AMENDMENTS TO THE DRAWINGS

Fig.1

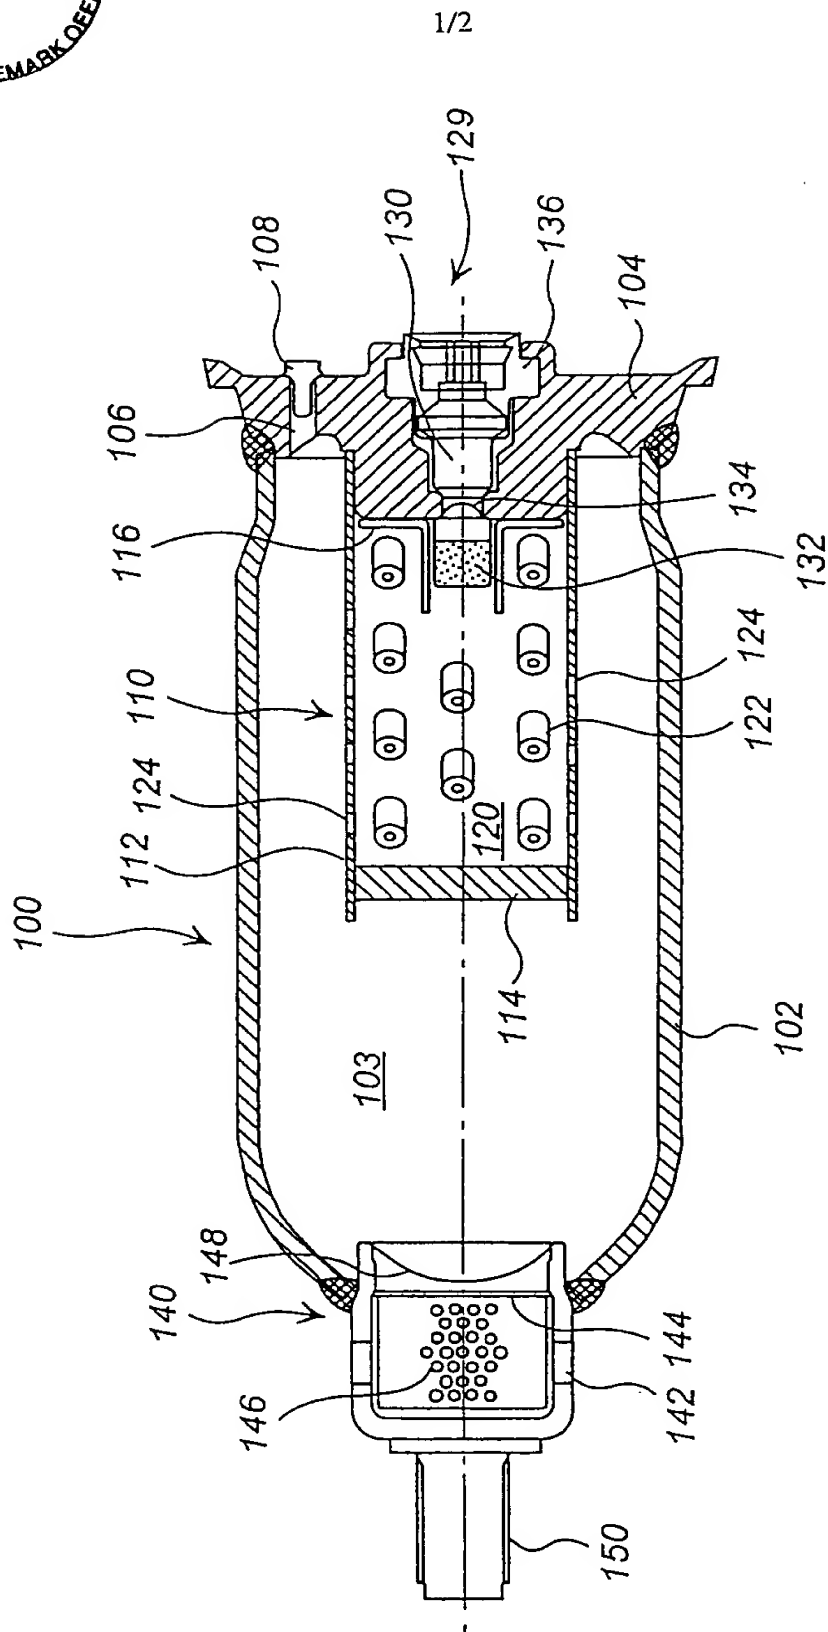
In Fig. 1, reference numeral 129 has been added to indicate an ignition unit.

Fig.2

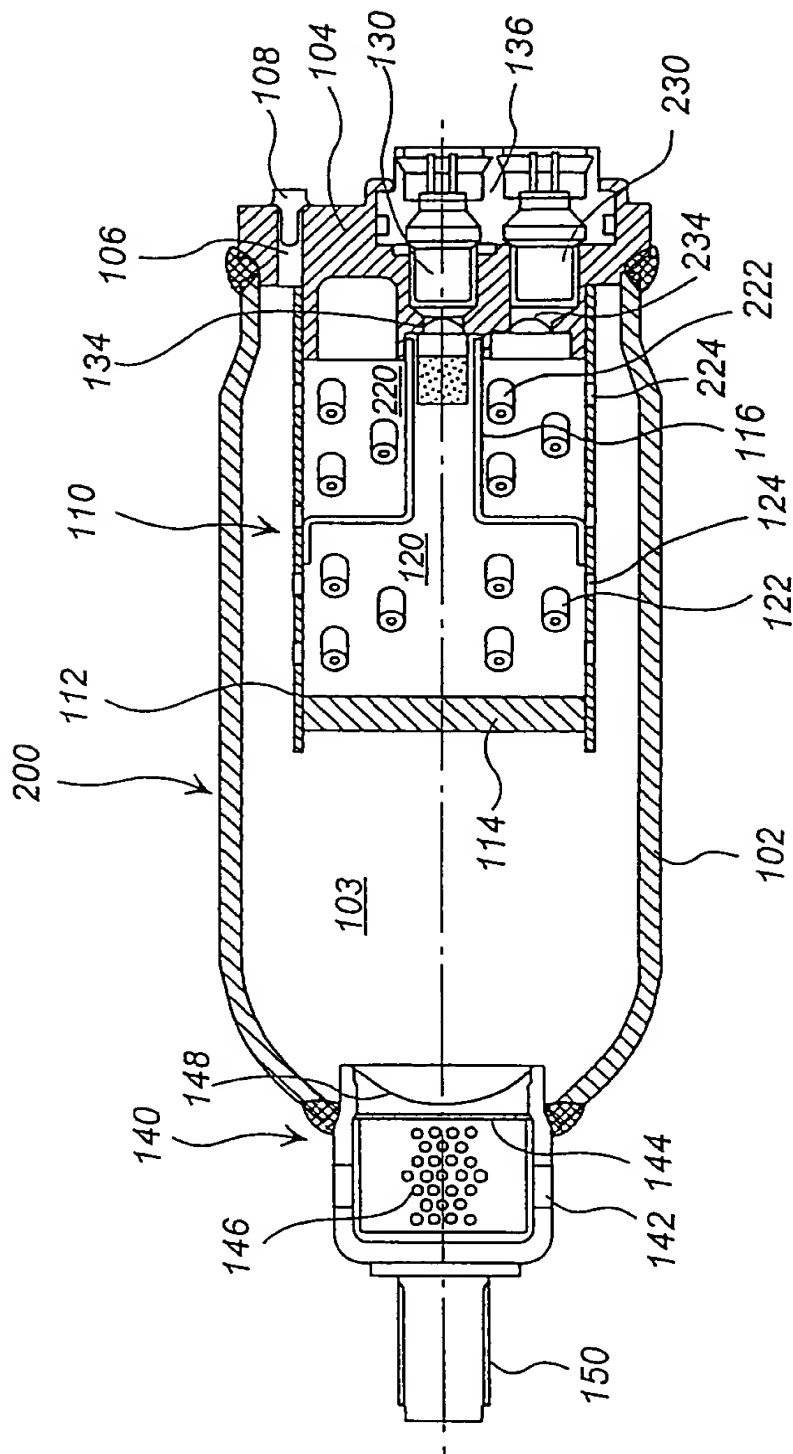
In Fig. 2, reference numeral 116 has been amended to indicate a partition wall that separates gas generating chamber 120 and a second gas generating chamber 220;

reference numeral 124 has been amended to indicate a communication hole communicating a gas generating chamber 120 with an inner space 103; and

reference numeral 222 has been amended to indicate a second gas generating agent.
